[Docket No. 2000-SW-51-AD; Amendment 39-11960; AD 2000-20-51]

Airworthiness Directives; Robinson Helicopter Company Model R22 Helicopters

2000-20-51 Robinson Helicopter Company:
Amendment 39-11960. Docket No. 2000-SW-51-AD.

Figure A

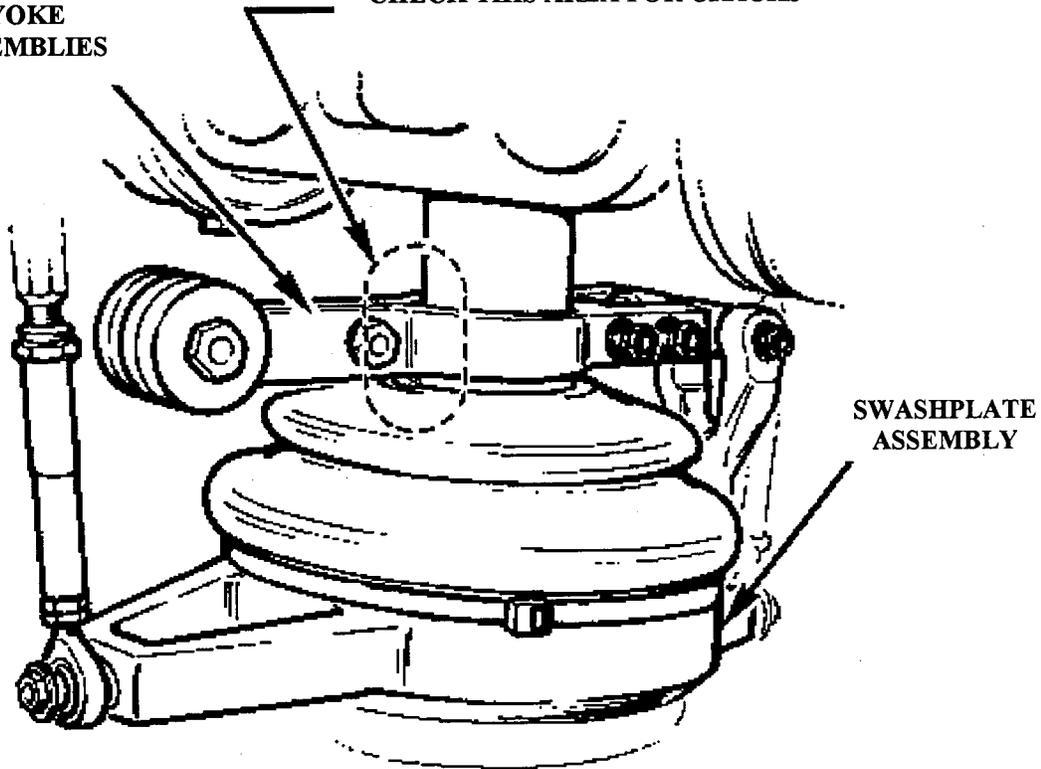
(a) Before further flight and thereafter before the first flight of each day, check each yoke for a crack. See Figure A.

CHECK THIS AREA FOR CRACKS

(b) If a yoke is cracked, before further flight, replace the yokes with airworthy yokes, P/N A203-7. Both yokes must be replaced with yokes, P/N A203-7.

(2) If the Lot identifier is from 24 through 43, if it is a letter code, or if it is illegible, replace yokes, P/N A203-5, with airworthy yokes, P/N A203-7. Yoke, P/N A203-7, cannot be installed with yoke, P/N A203-5.
